PROJECT **123A90 - HOLLANDSE KUST NOORD WIND PARK**
BLPH Project

MECHANICAL COMPLETION DOSSIER (ONSHORE)

SYSTEM	87 Instrumentation Systems incl. general control room equipment
SUBSYSTEM	87-10-13 Junction Box 00-JE-13002 and Multi-core cable (PCS System)

PUNCH ITEM ENTRY / CLEARANCE FORM

C30002056

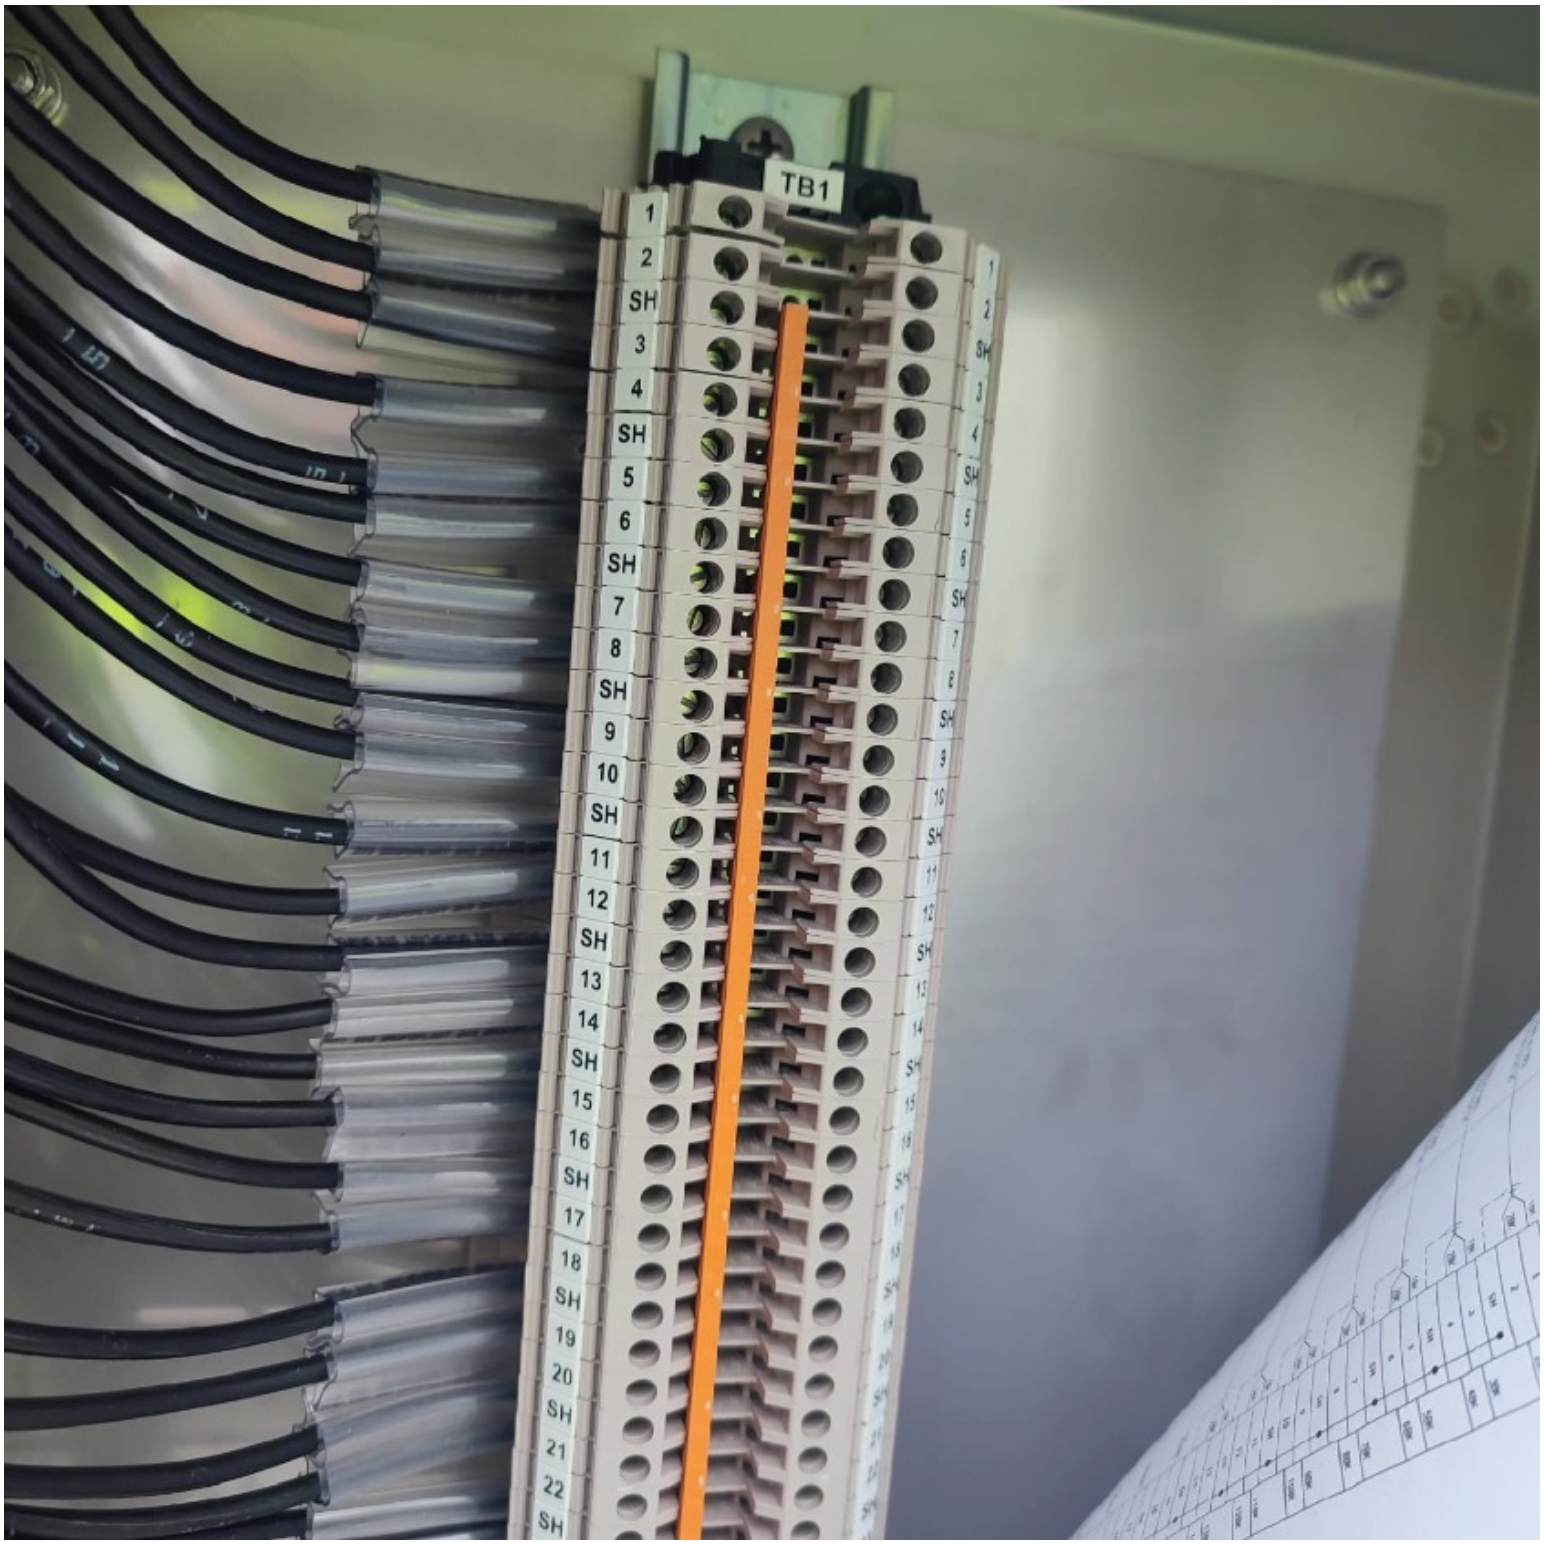
Identification tag wires missing inside00-JE-13002_connection.See attached photo.

Installed.

C30002061

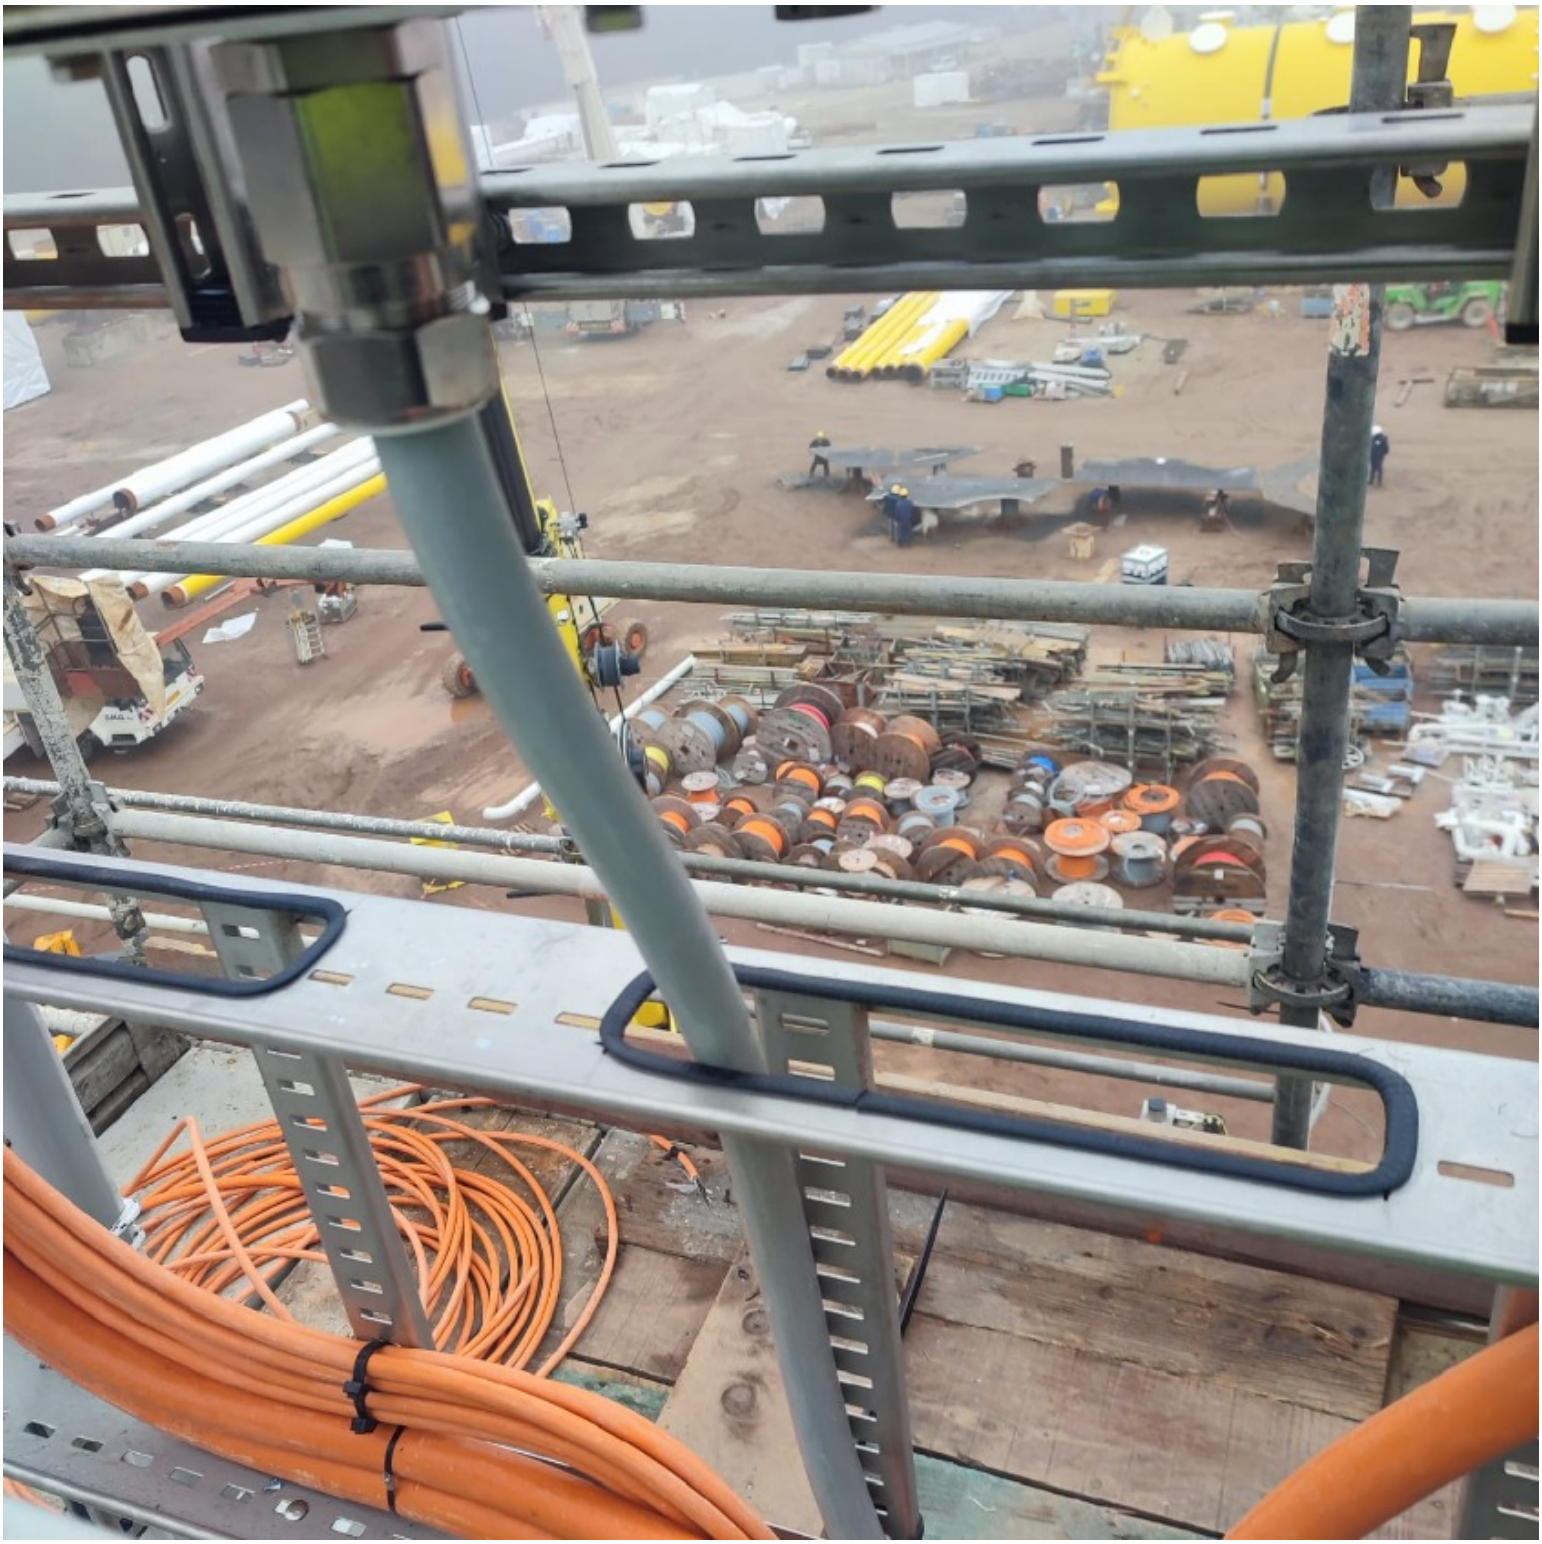
Bending radius is not within the specified limits under the 00-JE-13002 See attached photo.

DONE
